ADDENDUM TO THE CONTRACT

GLACIER FIRE STATION M/E UPGRADES & JUNEAU FIRE STATION GENERATOR REPLACEMENT

Contract No. BE22-108

ADDENDUM NO.: FIVE

AS BUILT OCT. 80 KO
DRAWN R. ZAGARS
DATE NOV. 1978
STRUCTURAL FOUNDATION PLAN

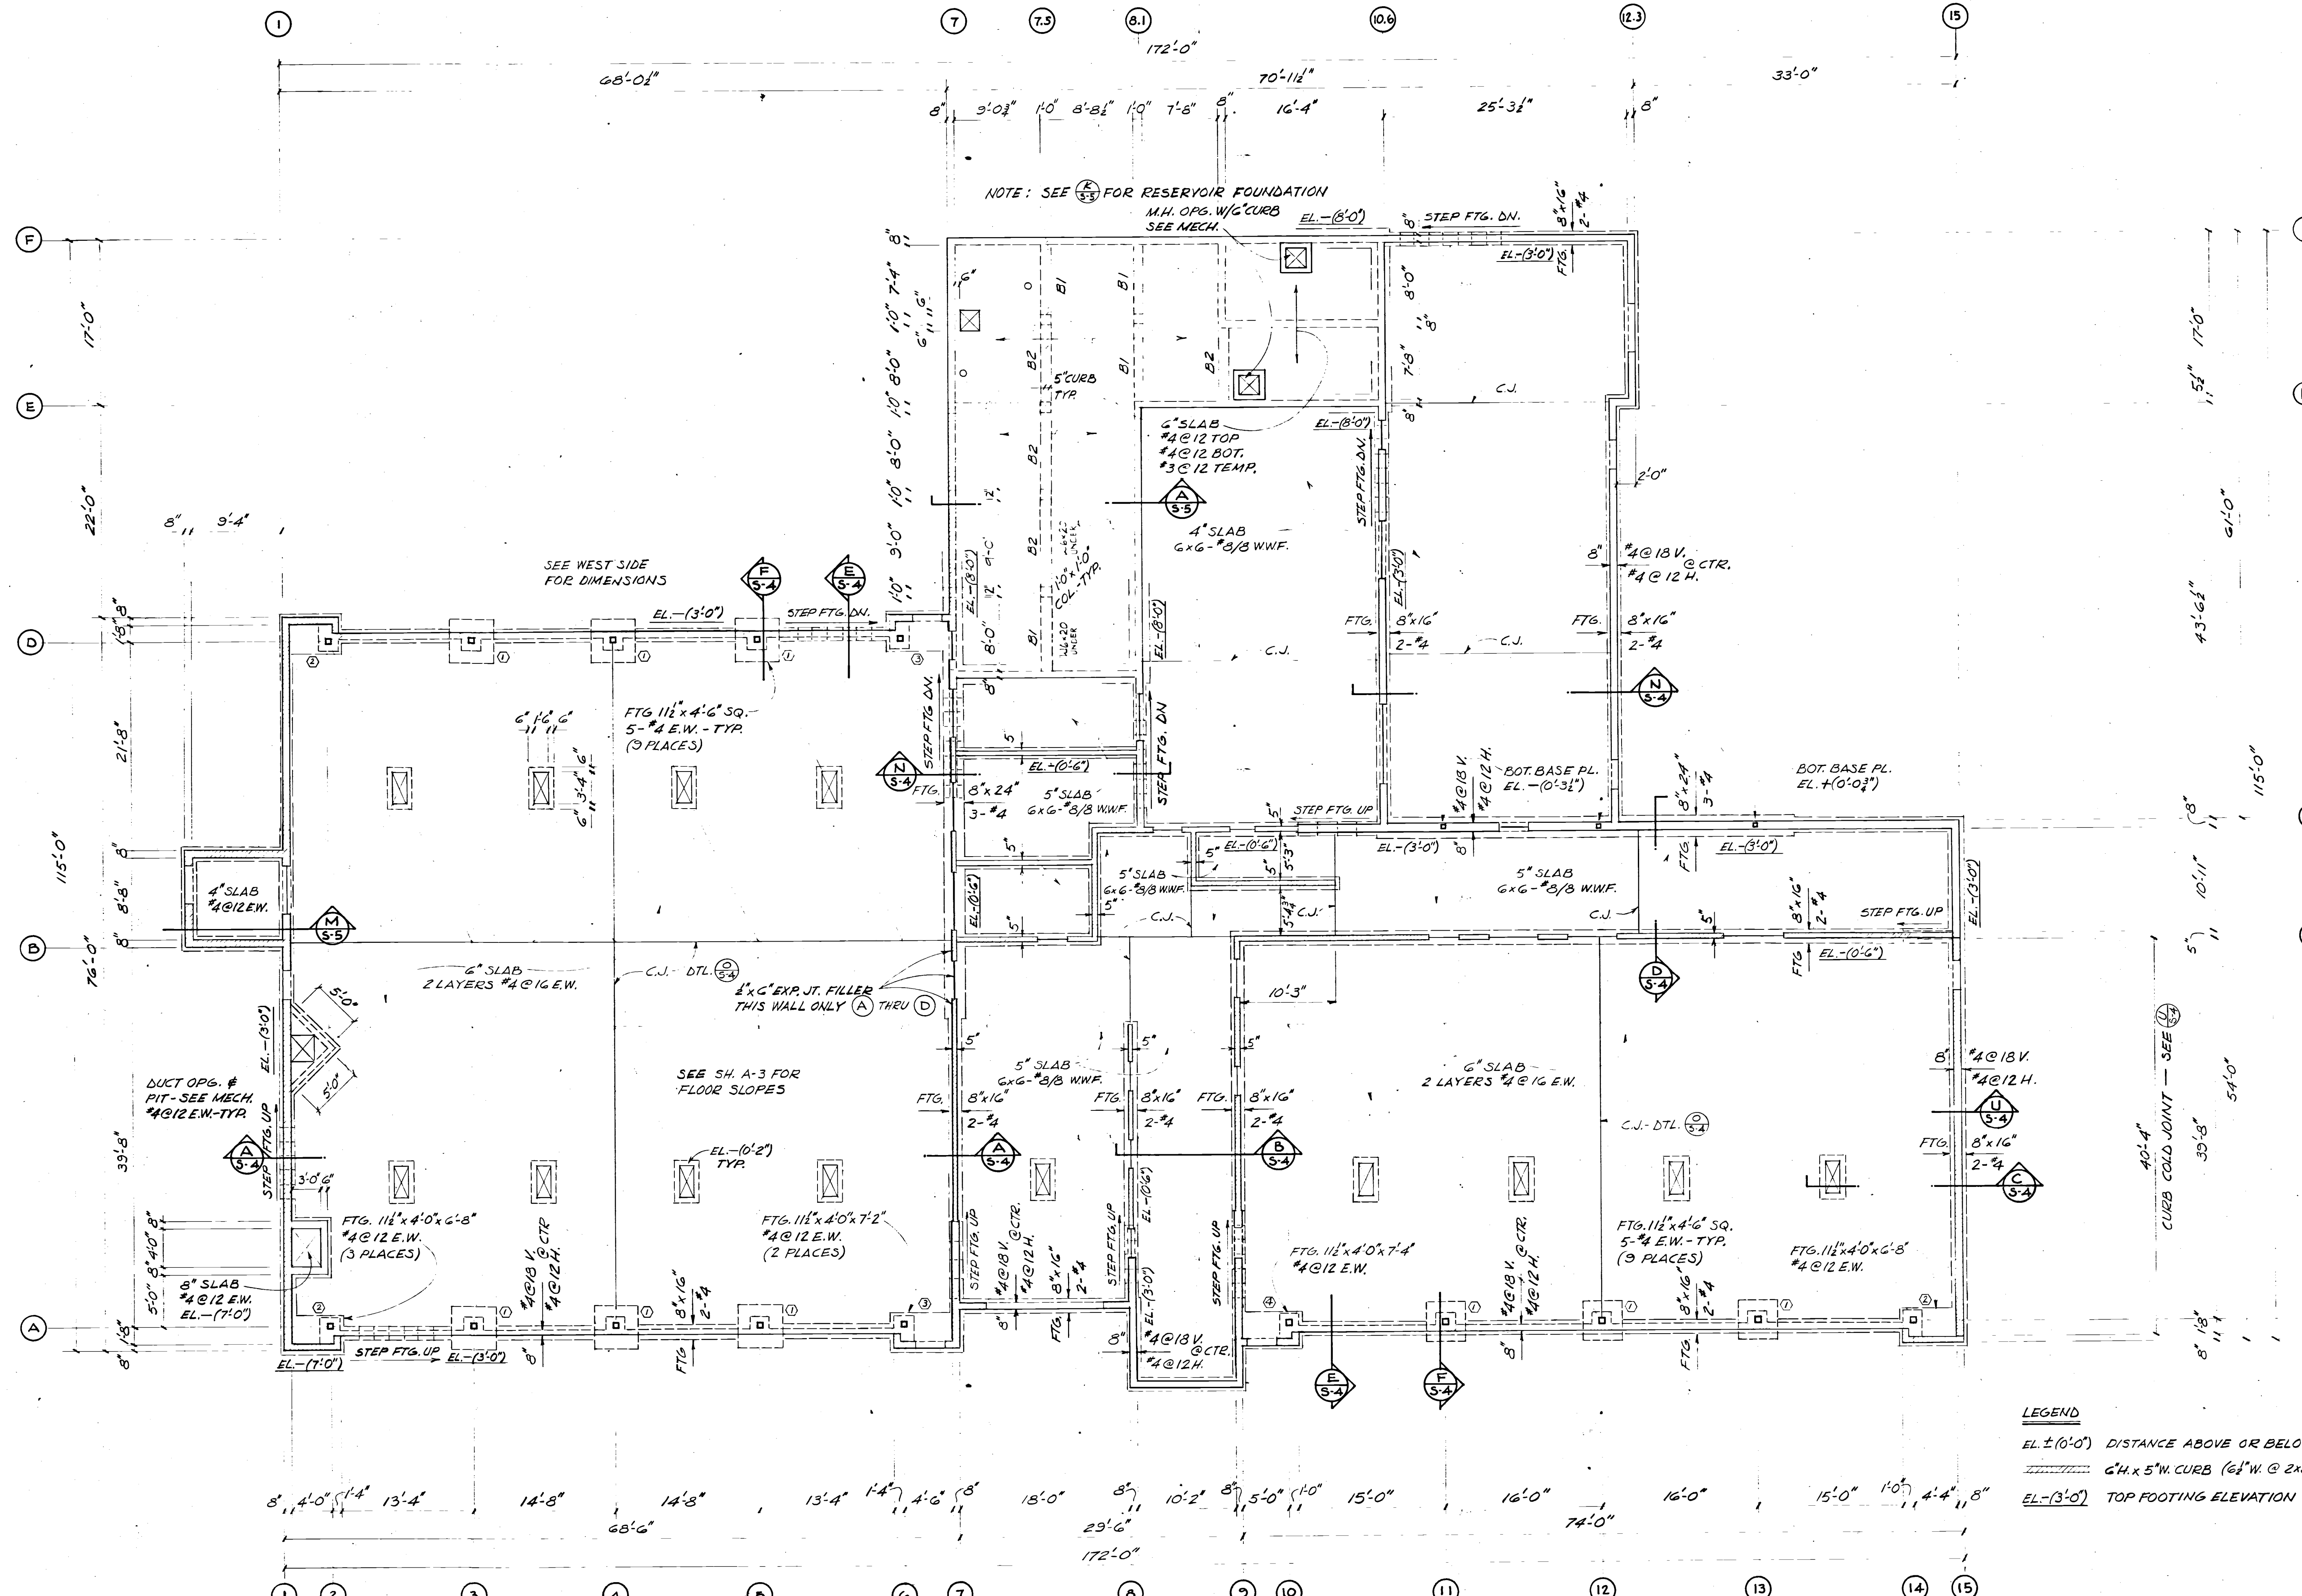
Question: "Can you please provide structural drawings for existing facility to confirm the floor framing type for areas where patching may be required?"

Question: "Please confirm if the existing first floor is slab on grade?"

Response: See attached original structural drawings.

Response: See attached original structural drawings.
